Service Kit 753-05343

REF: MTD-034

Subject: Upper Transmission Drive Belt
Path Alignment

Models Affected: 2006 Model Year 600-609
Series AutoDrive Units built
between November 1, 2005
and February 17, 2006

FIGURE 1

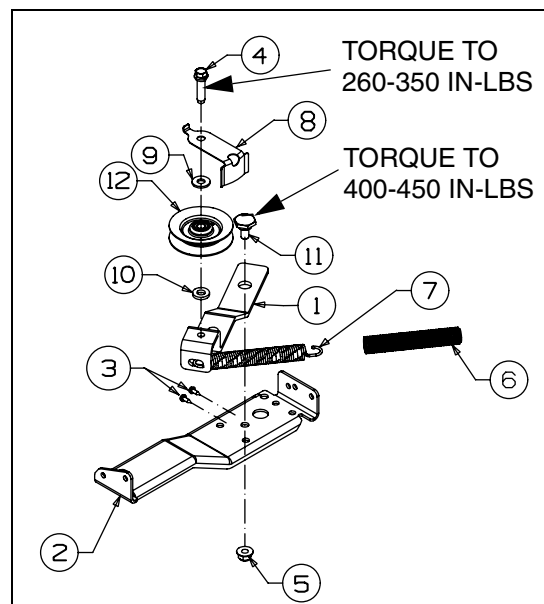
PURPOSE: This service kit provides the latest production transmission torque bracket and upper belt tensioning idler configuration. The new hardware reduces idler vertical movement thereby providing improved belt path alignment.

FIGURE 2

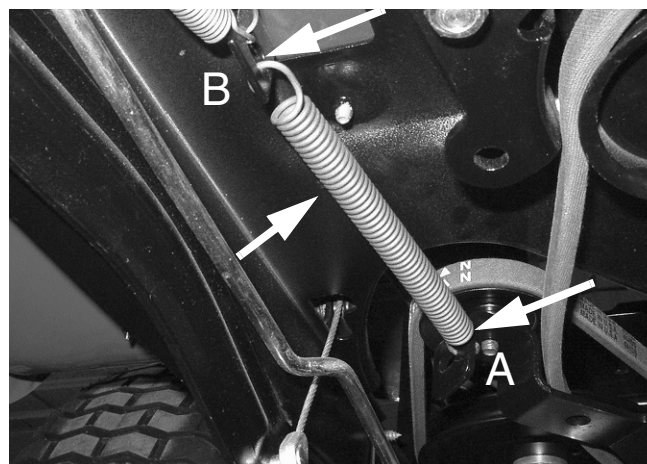
3. Refer to Figure 2. From the underside of the rider, disconnect the extension spring, 732-0384, that provides upper transmission belt idler tension, from the hook on the lower frame and the transmission's upper belt tensioning idler. Discard the spring.

18. Slip the Split Plastic Conduit, Item 6, onto the new Extension Spring, Item 9. Install the new spring as shown in Figure 2.

FIGURE 6

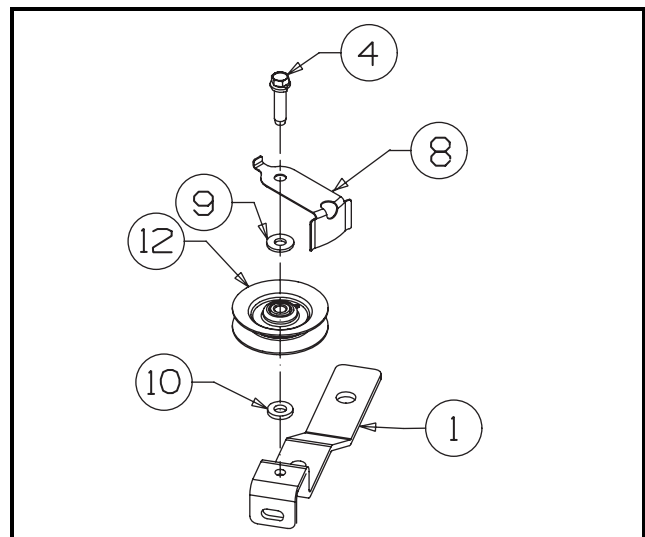
12. Assemble the "V" Type Idler Pulley, Item 12, Belt Guard, Item 8, and Flat Washers, Items 9 and 10, to the Idler Bracket, Item 1, using SEMS TapTite Screw, Item 4. Do not tighten the 3/8" mounting screw. Leave about two threads from tight, so that the belt can be installed in a later step.

FIGURE 7

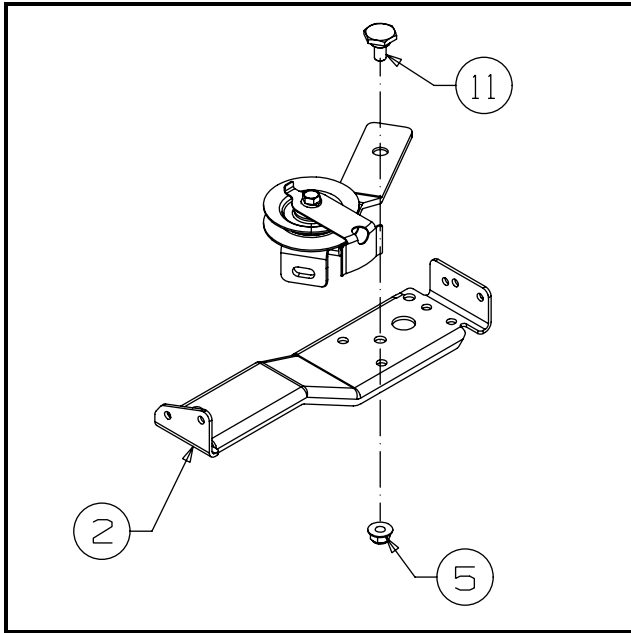
13. Assemble the new Idler Bracket, Item 1, subassembly onto the new Torque Bracket, Item 2, using the new Shoulder Screw, Item 11, and Flange Lock Nut, Item 5, as shown in Figure 7.
